Access Compliance Report

Public Rights-of-Way

(Curb Ramps)

Intersection ID: 12563	Main Street: E_9TH_ST	Cross Street: N_MYERS_ST	Location: N
ADA ID: F7CEA964BF4D	Ramp Type: PerpDiag	Initial Pass/Fail: Fail	Overall Compliance: No
Severity Score: 42.5			
Codes/Mitigation Info/Possible Solution		Field Measurements/Component Compliance

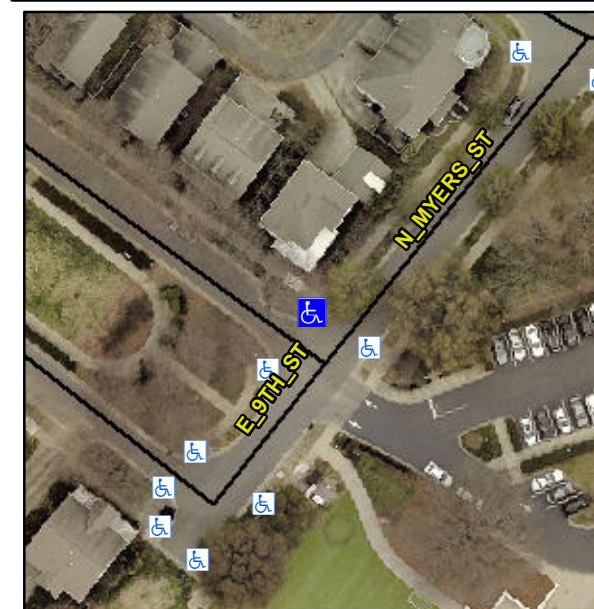
Not Found, R304.5.1, R304.5.3

Compliance	Description	Data	Compliance	Description	Data
N/A	Ramp Length (in)	71.0	Yes	Ramp Slope (%)	6.7
No	Ramp Width (in)	34.0	No	Ramp XSlope (%)	9.1
N/A	Flare Type LT	N/A	N/A	Flare Type RT	N/A
N/A	Flare Slope LT (%)	N/A	N/A	Flare Slope RT (%)	N/A
N/A	Flare Traversable LT?	N/A	N/A	Flare Traversable RT?	N/A
N/A	Landing Length (in)	N/A	N/A	DWS Provided?	N/A
N/A	Landing Width (in)	N/A	N/A	DWS Contrast?	N/A
N/A	Landing Slope (%)	N/A	N/A	DWS Length (in)	N/A
N/A	Landing X Slope (%)	N/A	N/A	DWS Full Width?	N/A
N/A	Landing Curb? (Y/N)	N/A	N/A	DWS Offset (in)	N/A
N/A	Shared Landing?	N/A			
N/A	Gutter Ponding?	N/A	N/A	Gutter Slope (%)	N/A
N/A	Gutter Lip Ht (in)	N/A	N/A	Gutter X Slope (%)	N/A
N/A	Painted X Walk1?	No	N/A	Painted X Walk2?	No
	X Walk 1 Direction	To SW		X Walk 2 Direction	To SE
N/A	X Walk 1 Width (in)	N/A	N/A	X Walk 2 Width (in)	N/A
	X Walk 1 Slope (%)	2.0		X Walk 2 Slope (%)	5.0
	X Walk 1 X Slope (%)	3.1		X Walk 2 X Slope (%)	5.6

Remove & Replace Curb Ramp With Two New Directional Ramps or Equivalent.
